ADDENDUM NUMBER 1

**Professional Development Center
and Kitchen**

For
SAN BERNARDINO CITY UNIFIED SCHOOL DISTRICT
Bid No F16-05

December 28, 2015

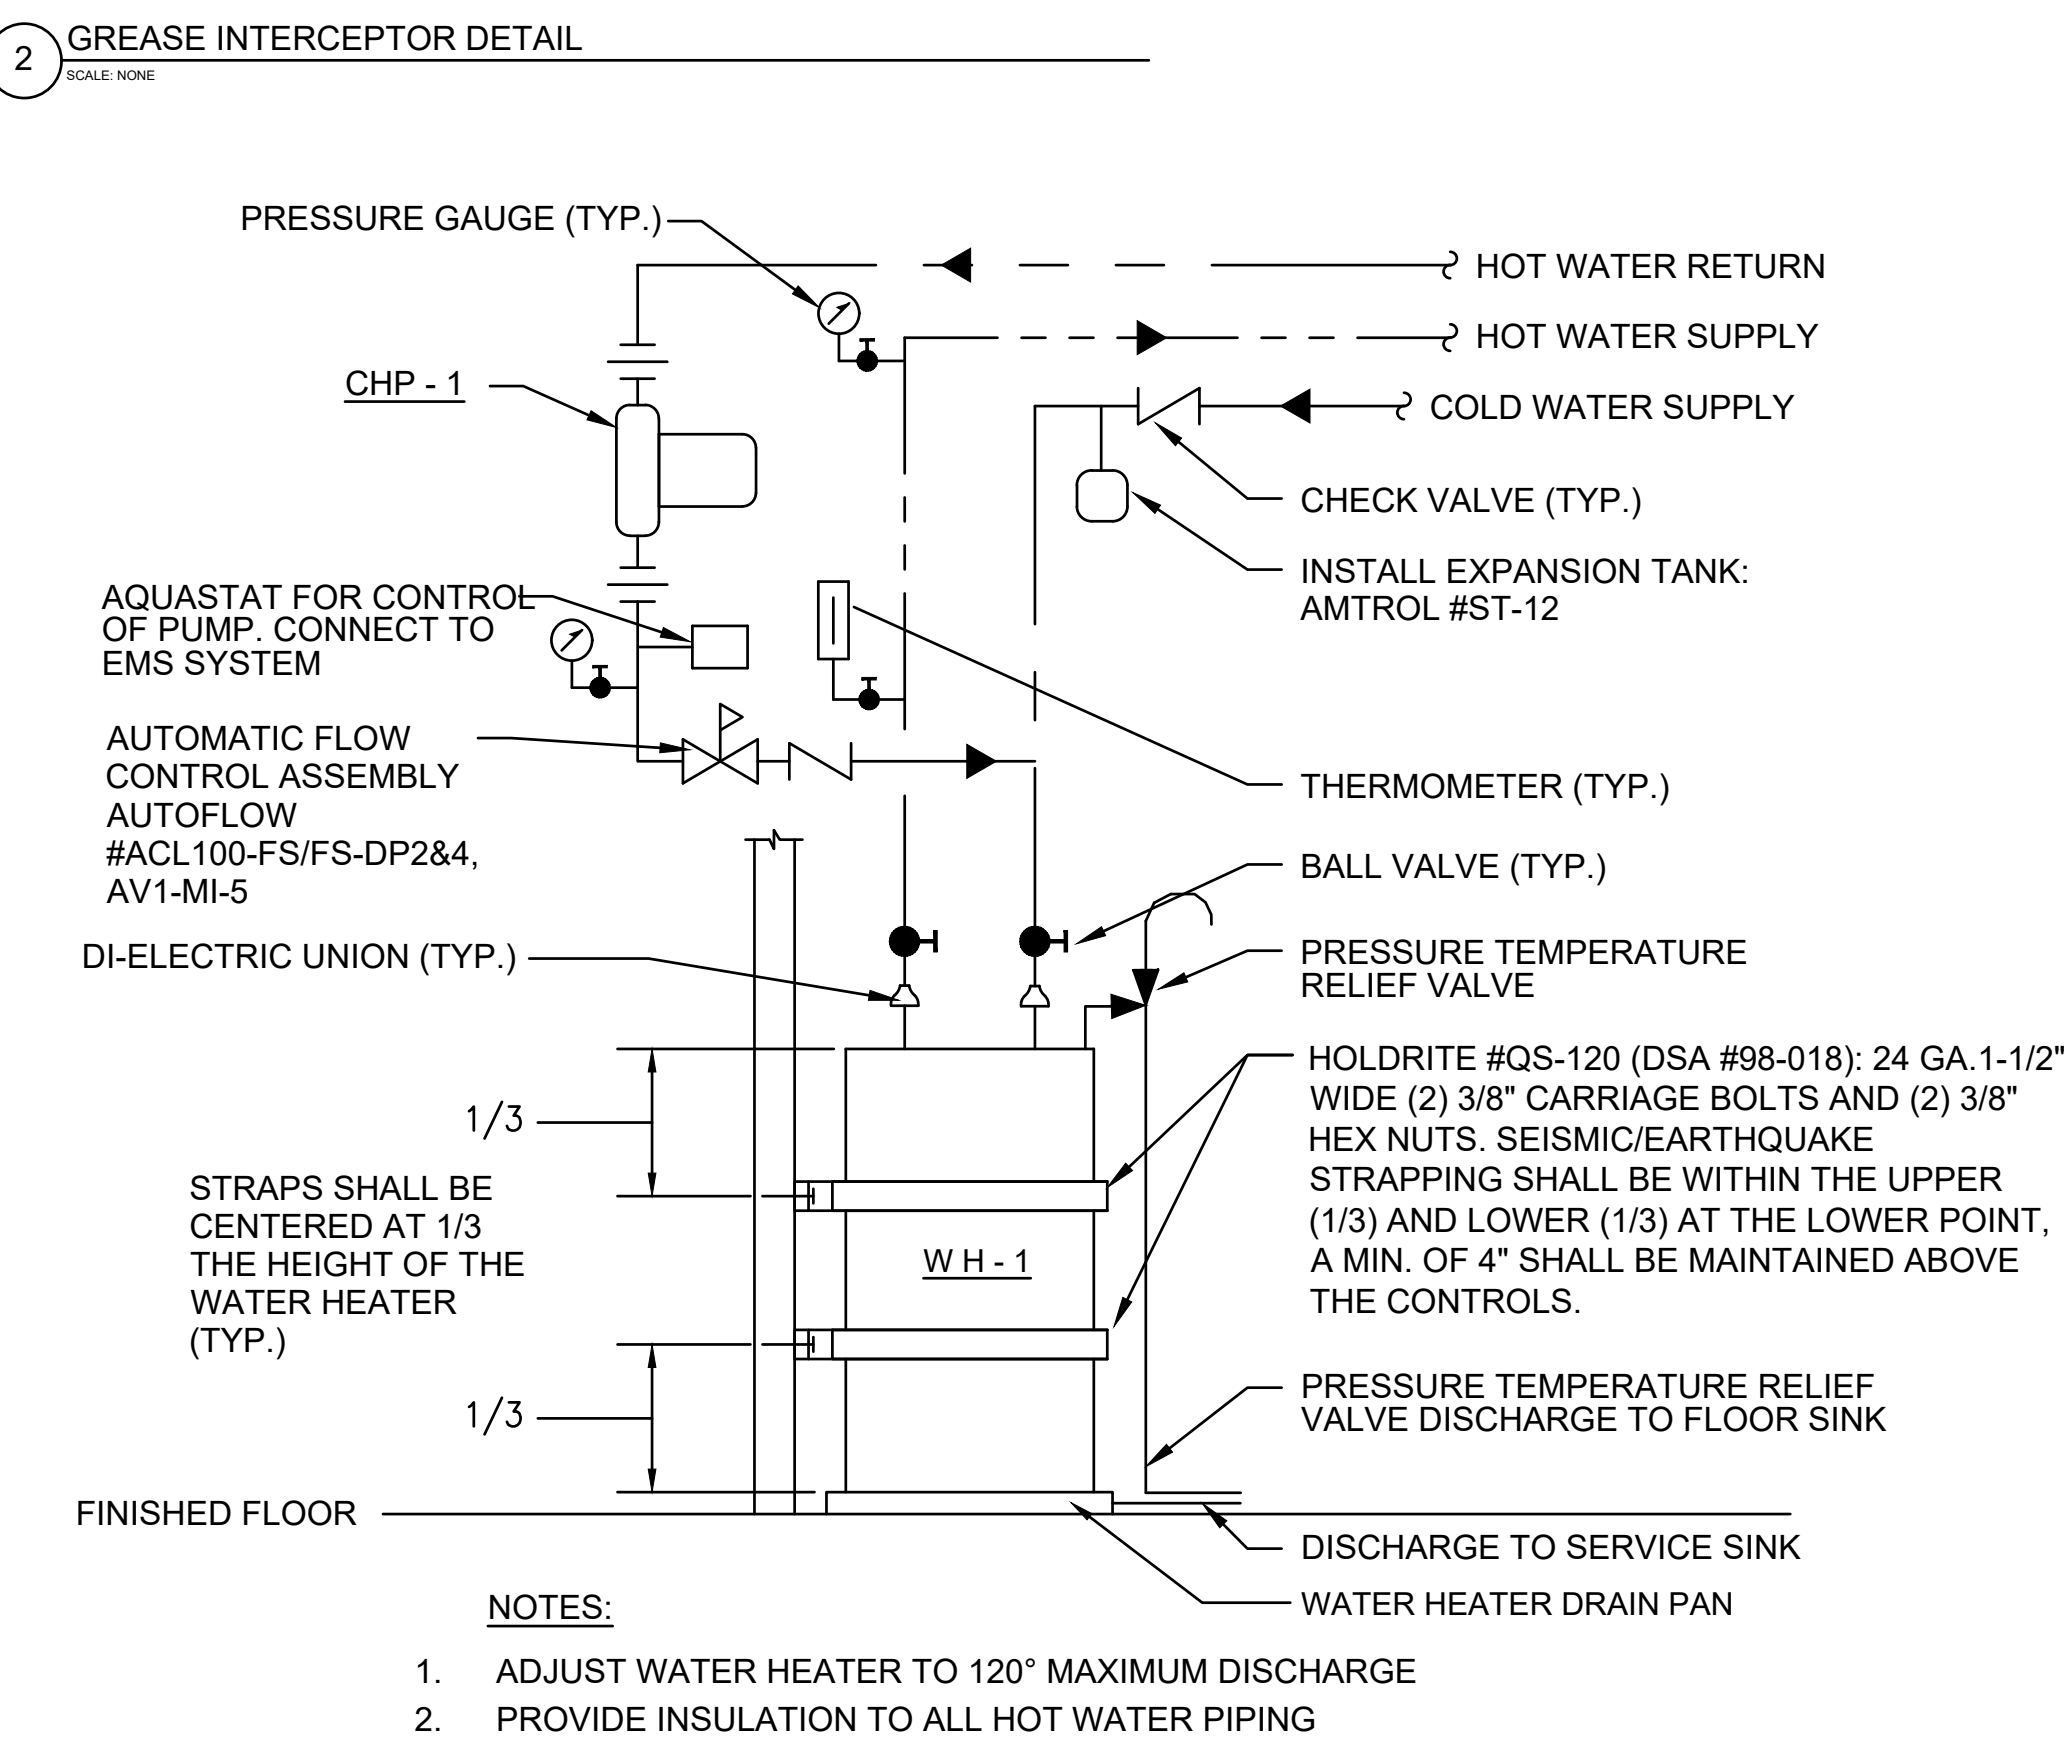
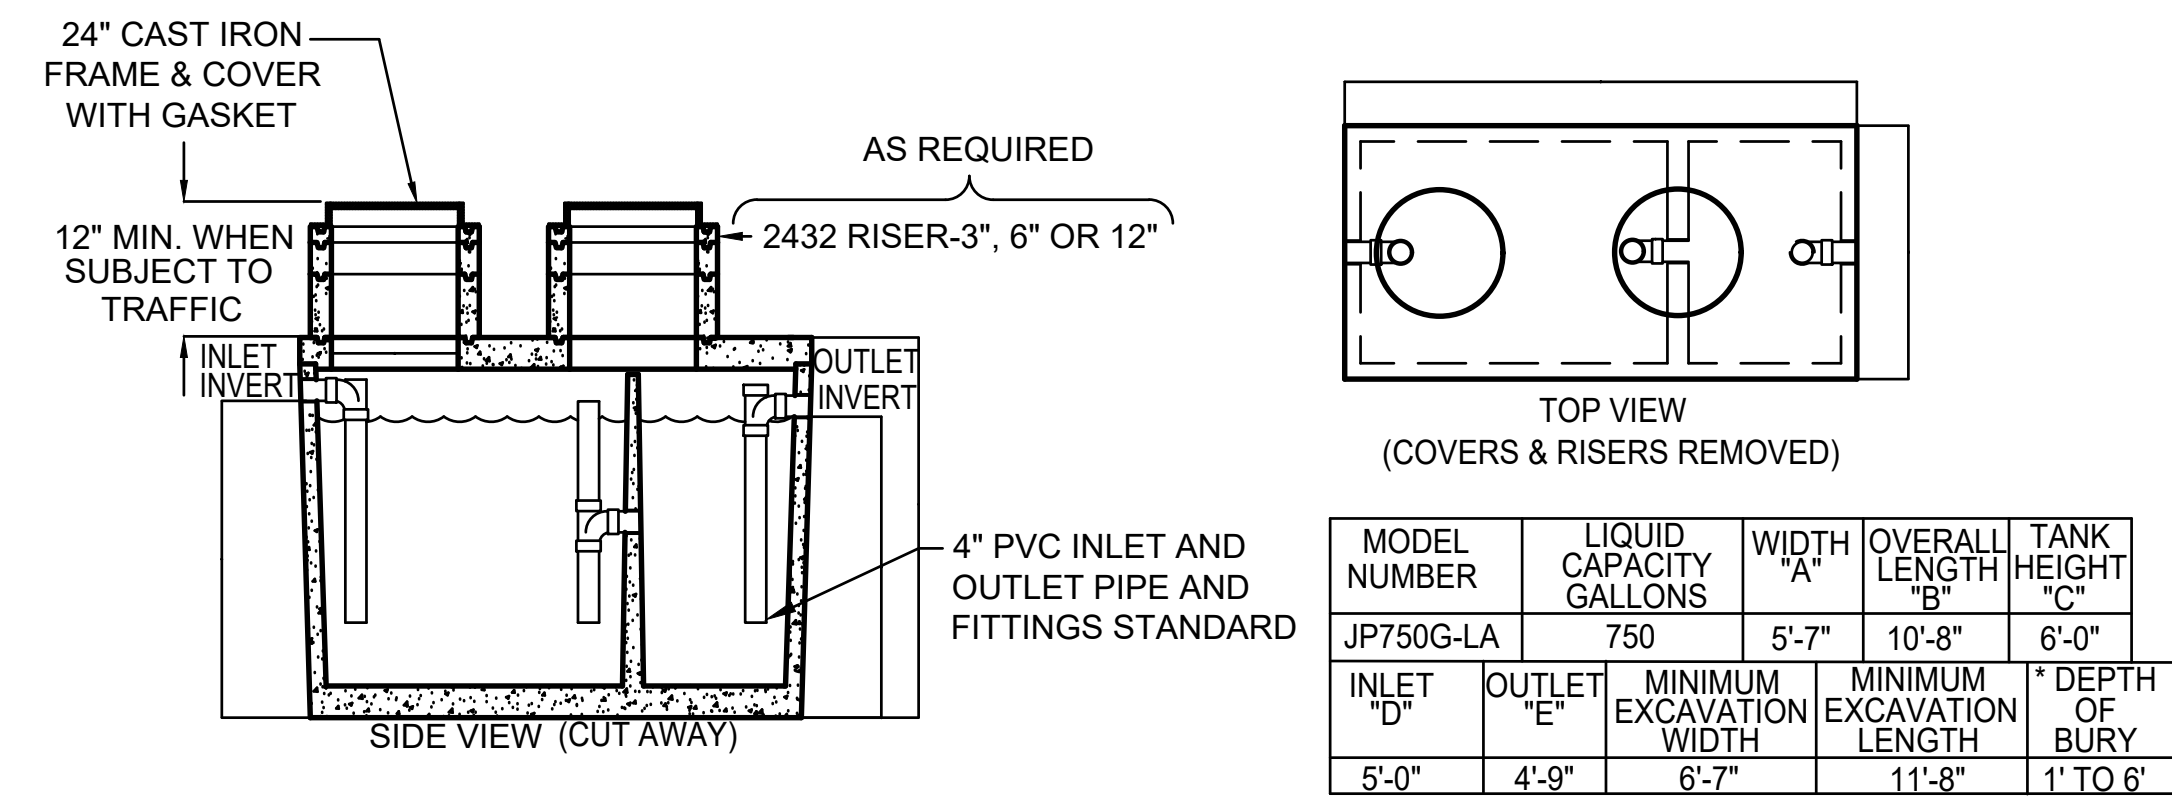
Item Number 31; Reference; Sheet P-3.01, Plumbing Details; Replace this sheet with attached sheet **P-2.01, Plumbing Details.**

Note: Revised sheet adds detail 4 - Drywell Assembly.
